Flat 2, 12 Lyndhurst Gardens
NW3 5NR

Basement Impact Assessment
Audit

For
London Borough of Camden

Project Number: 12985-62

Plate 1: Showing Section C-C' (Across Flat 1), Showing Maximum 12mm Settlement Beneath Underpins

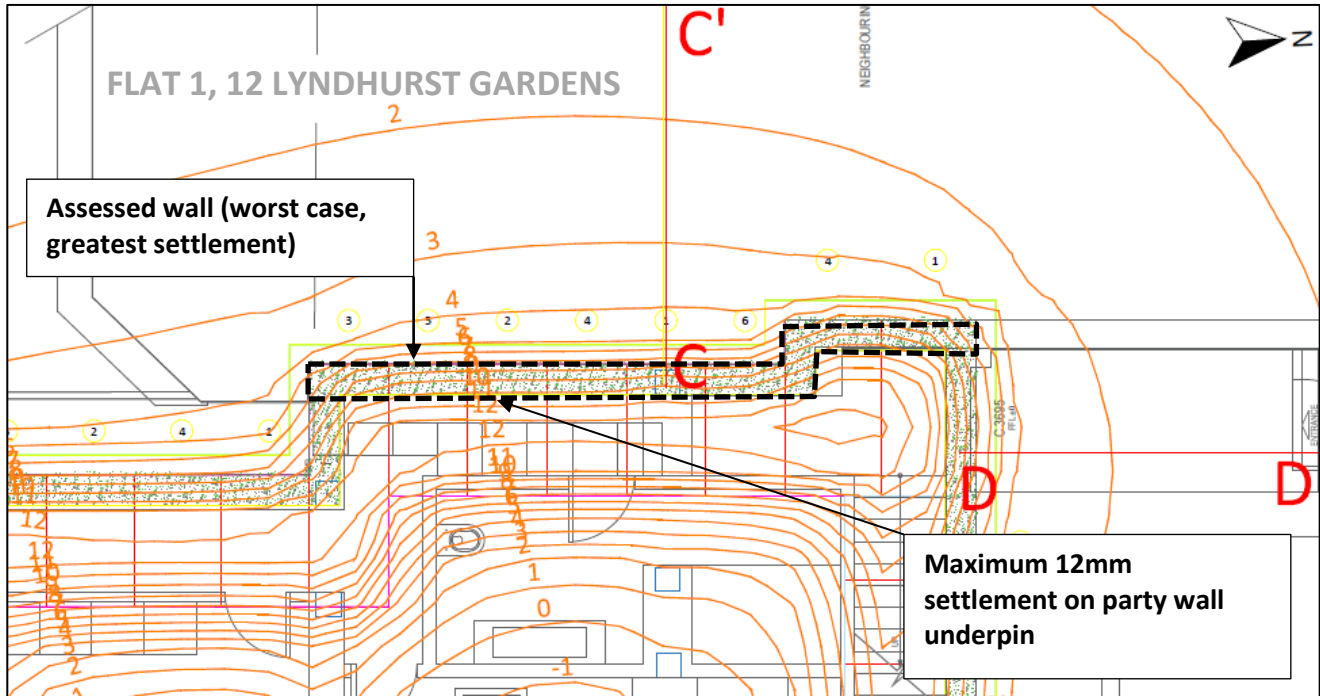
Campbell Reith, as part of a BIA Audit for the site, highlighted a concern regarding limiting lateral movements stated (2mm to 4mm) in order to keep damage impacts to neighbouring structures within Category 1 (Very Slight).

We have reviewed our assessment and would note that whilst the limiting lateral movements are low within our report, it is CGL's experience that substantial lateral movements do not materialise in underpinning works where ground loss is controlled during pin excavation and the underpins are effectively propped to restrict rotational movements. Therefore, in line with previous experience on underpinning sites elsewhere within Camden we would note that the horizontal strain criterion is potentially overly onerous for situations such as this, and on review the Rankin criterion of an angular distortion might be more appropriate.

An assessment has been provided for Wall C-C', shown on Plate 1 below. Predicted movements along this wall section (party wall with Flat 1, 12 Lyndhurst Gardens) show maximum settlement values of 12mm, giving an angular distortion of 1/666 across the building width (8m) for Flat 1. Allowing for a typical 5mm construction movement (compression of dry pack/movement of loose bricks etc.) would result in total predicted settlement of some 17mm, and a 1/470 angular distortion assuming that Flat 1 is 8m wide perpendicular to its underpinned wall.

This would fall into Rankin Risk Category 2, with an associated description of building risk of 'slight: possible superficial damage which is unlikely to have structural significance'. This description is consistent with that for Burland category 1 to 2 (Very Slight to Slight), noting however that the predicted movements at Lyndhurst Gardens re very much towards the lower end of the range offered by Rankin (Limiting settlement of 10mm to 50mm, with maximum building slope of 1/500 to 1/200) for this Risk Category.

On this basis, we would propose to adopt the above criterion, in the expectation/requirement of the basement underpinning being constructed in a controlled and appropriate manner with a good standard of workmanship and appropriate propping.

Assessments undertaken for the party wall with Flat 1, 12 Lyndhurst Gardens, indicates predicted settlement of some 17mm, and a 1/470 angular distortion. Horizontal movements for well-constructed underpin foundations tend to be low, therefore the Rankin criterion has been adopted, giving rise to a predicted damage category of 0 to 1 (negligible to very slight) and monitoring trigger limit values are provided.
